**LETTER OF SUBMITTAL**  
**KFM Skyway Project # 04-012024**

Subject: **USI - KFM NCR #59 (METS NCR #45) Response to Caltrans State Letter #5815**

Subject: Response to Caltrans State Letter # 5.03.01-005815  
KFM NCR 59

*Subject: Response to KFM-SUB-003348R00: USI KFM NCR #59 (METS NCR #45) Response to Caltrans State Letter #5815*

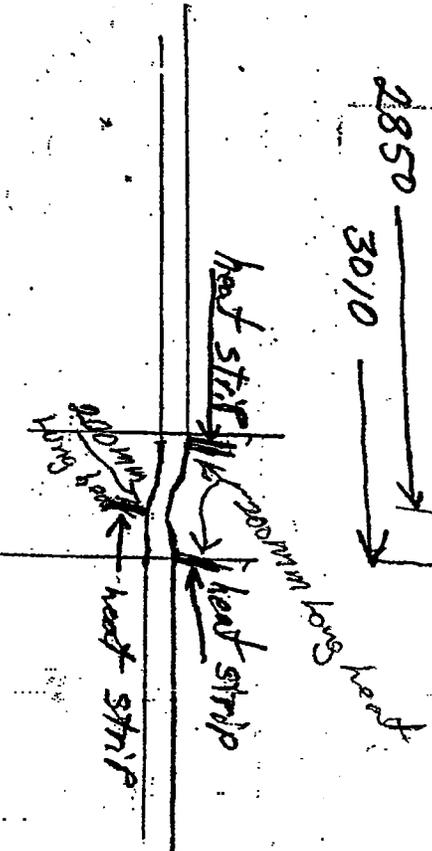
<b>Sept 29, 2004</b>	Ralph Seeley	Production	04-34
<b>JOB NUMBER:</b>	<b>JOB NAME:</b>	DRAWING	CODE/SPECIFICATION
23932	SFOBB	50 Girder 3A	AWS D1.5
<b>NONCONFORMANCE:</b>			
Web PL Pa 50 has a dent 380mm long by 150mm deep in the top of the web. 8mm max distortion. This problem was caused during handling when the piece was rolled over in the welding process.			
<b>QA MANAGER C. Amonson</b>		<b>DATE: 9/29/04</b>	
<b>RECOMMENDED DISPOSITION.</b>			
Areas distorted shall be straightened by application of a limited amount of localized heat with minimal mechanical assistance. The temperature of heated areas shall not exceed 1100 degrees F. (600 degrees C.).			
All application of heat to base metal shall be controlled by using Temp Sticks or Thermocouples to assure that heat does not exceed allowable.			
Heat lengths will be 200mm long. Placement shown on attached sketch.			
<b>QA MANAGER</b>	<b>DATE</b>	<b>PROJECT MANAGER</b>	<b>DATE</b>

The Engineer **has** reviewed **KFM-SUB-002968R00: USI Heat Straightening Request 04-34** regarding the request to repair web plate, pa50. The damaged web plate, pa50 is hereby rejected in accordance with Section **55-1.04** of the Standard Specifications **until** such time as the Contractor can demonstrate it conforms to the contract requirements. The Contractor should nondestructively test the web plate along the axes of bending in order to confirm additional damage **has** not occurred. After performing the nondestructive testing, the State QA inspector will observe the applications of heat in accordance **with** the subject submittal. The Engineer **has** concerns regarding the Contractor's ability to adequately handle material **as** noted in State Letter **No. 5815**.

1500mm long area  
Flat within 2mm after heat

Heat Straightening Comp.  
Q.C. notified to Mag.  
affected area. K. E

## Universal Structural, Inc HEAT STRAIGHTENING REQUEST

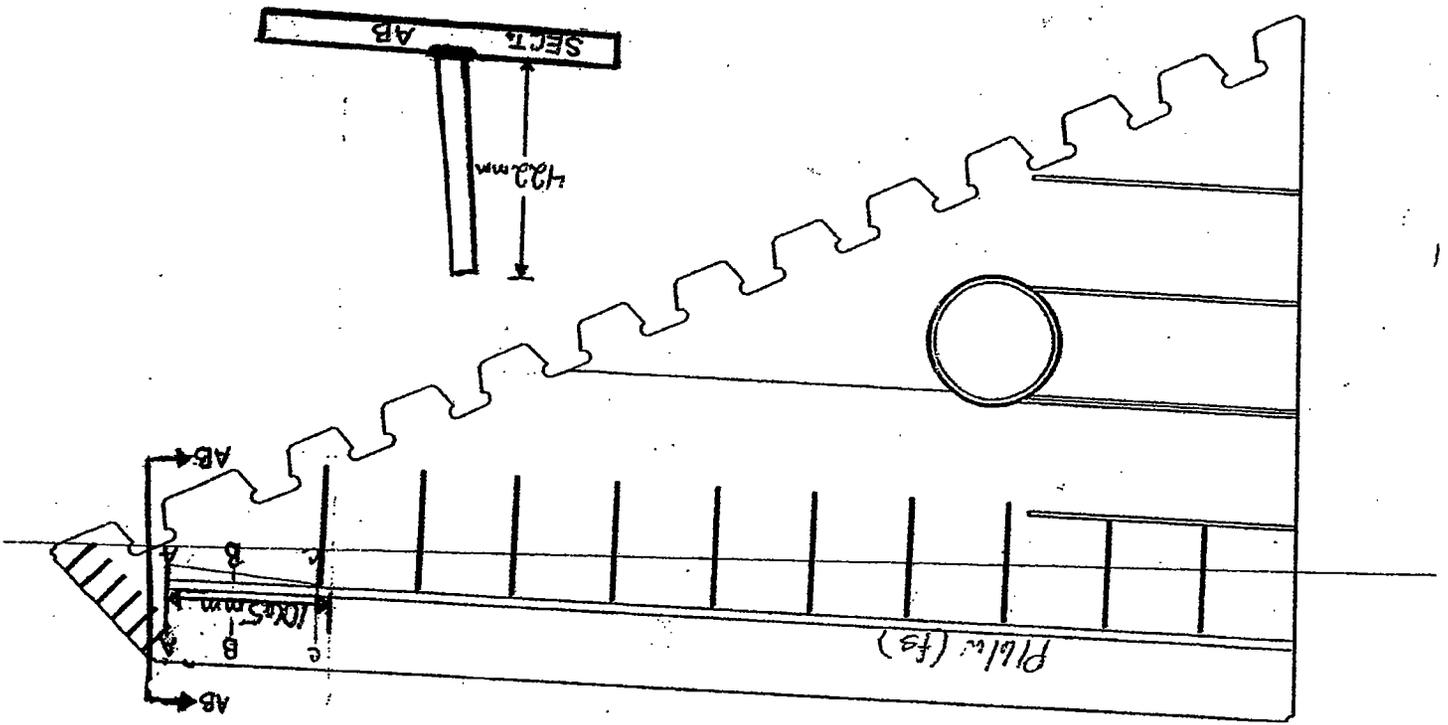
<b>DATE:</b>	<b>INITIATOR</b>	<b>DEPARTMENT:</b>	<b>HSR NUMBER:</b>
Oct 6, 2004	Ralph Seeley	Production	04-33 Rev.1
<b>JOB NUMBER</b>	<b>JOB NAME:</b>	<b>DRAWING</b>	<b>CODE/SPECIFICATION</b>
23932	SFOBB	58	AWS D1.5
<b>NONCONFORMANCE:</b> Plate P161w on diaphragm assembly pa58 Girder 1A, is bent from the last p161g stiffener to the end. I deviates 28mm from straight at the end. The plate was bent while being rolled in the welding process. A supervisors meeting has been held to review the rigging technique.			
<b>QA MANAGER K. Stephenson</b>		<b>DATE: 10/6/04</b>	
<b>RECOMMENDED DISPOSITION:</b> Areas out of tolerance shall be straightened by application of a limited amount of localized heat with minimal mechanical assistance. The temperature of heated areas shall not exceed 1 100 degrees F. (600 degrees C.). All application of heat to base metal shall be controlled by using Temp Sticks or Thermocouples to assure that heat does not exceed allowable. Weld joints are to be heated on the stiffener side of the joint and parallel to the weld. This line heat will be located approximately 1 to 3 inches from the weld joint on the outside of the surface that is distorted. See the attached sketch for further details

The Engineer has reviewed **KFM-SUB-002912R00: USI Heat Straightening Request 04-33** regarding requests to heat straighten stiffener, p161w on diaphragm pa58. The subject submittal is not approved. The material appears to be plastically deformed and may have been damaged during handling. The Engineer requests the Contractor investigate the cause of the plastic deformation. A review of the details regarding the deformation is necessary before any repair procedures can be evaluated.

OK	OK	G-C
OK	OK	B-B
3.5mm	Ø8	A-A
original 1st check Heat		SECTION FROM SQUARE SECT. AB

1. Sketch of each piece showing where the heat will be applied.
2. Estimate of the number of applications of heat to bring the material into conformance.
3. Explanation of how Fabrication Procedures will be modified and improved,

Universal Structural, Inc  
Heat Straighten Request

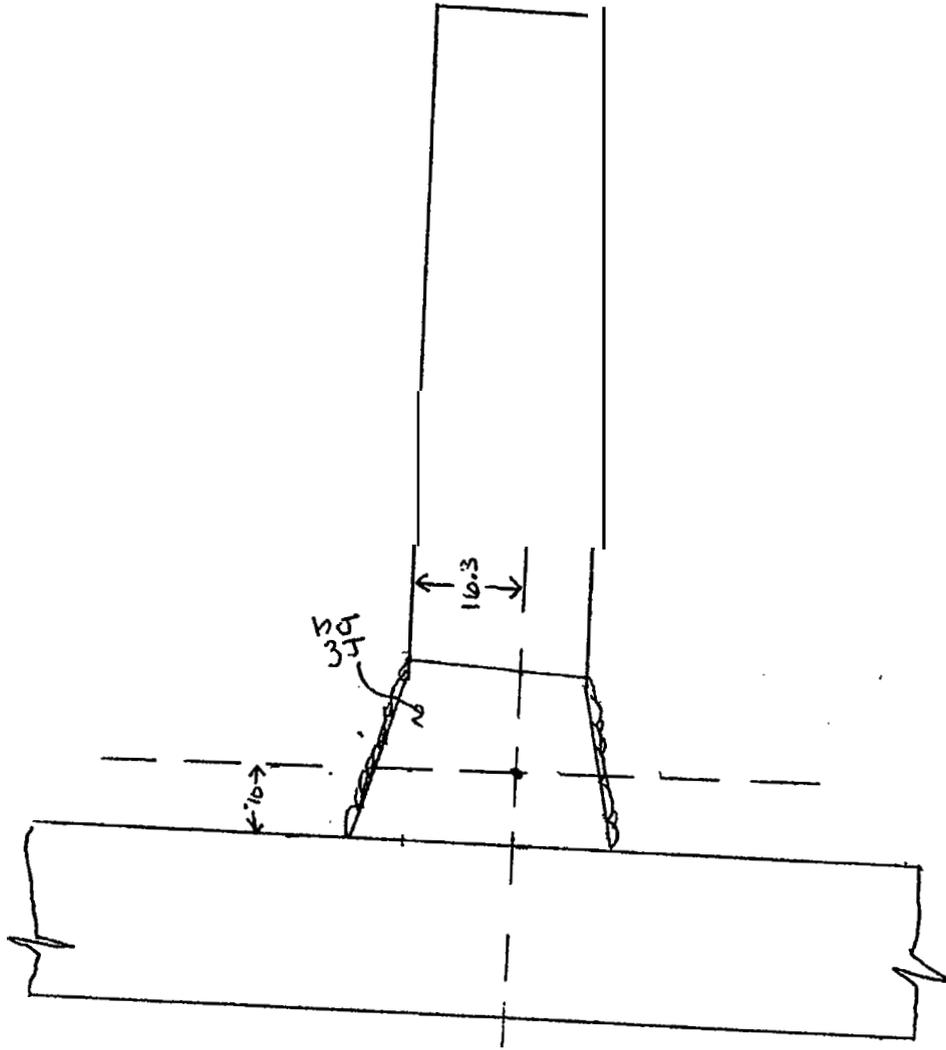
DATE: <b>Sept 21, 2004</b>	INITIATOR <b>Ralph Seeley</b>	DEPARTMENT: Production	HSR NUMBER: <b>04-33</b>
JOB NUMBER: <b>23932</b>	JOB NAME: <b>SFOBB</b>	DRAWING 58	CODE/SPECIFICATION AWS D1.5
<b>NONCONFORMANCE:</b> Plate P161w on diaphragm assembly pa58 Girder 1, is bent from the last p161g stiffener to the end. It deviates 28mm from straight at the end. <b>BENT BEING ROLLED</b> <del>stiffener</del>			
QA MANAGER C. Amonson		DATE: 5/4/04	
<b>RECOMMENDED DISPOSITION:</b> Areas distorted shall be straightened by application of a limited amount of localized heat with minimal mechanical assistance. The temperature of heated areas shall not exceed 1100 degrees F. (600 degrees C.). All application of heat to base metal shall be controlled by using Temp Sticks or Thennocouples to assure that heat does not exceed allowable. Weld joints are to be heated on the stiffener side of the joint and parallel to the weld. This line heat will be located approximately 1 to 3 inches from the weld joint on the outside of the surface that is distorted. See the attached sketch for further details.

SUPERVISERS MEETING HELD  
TO REVIEW RIGGING TECHNIQUES

REJECT 9/23
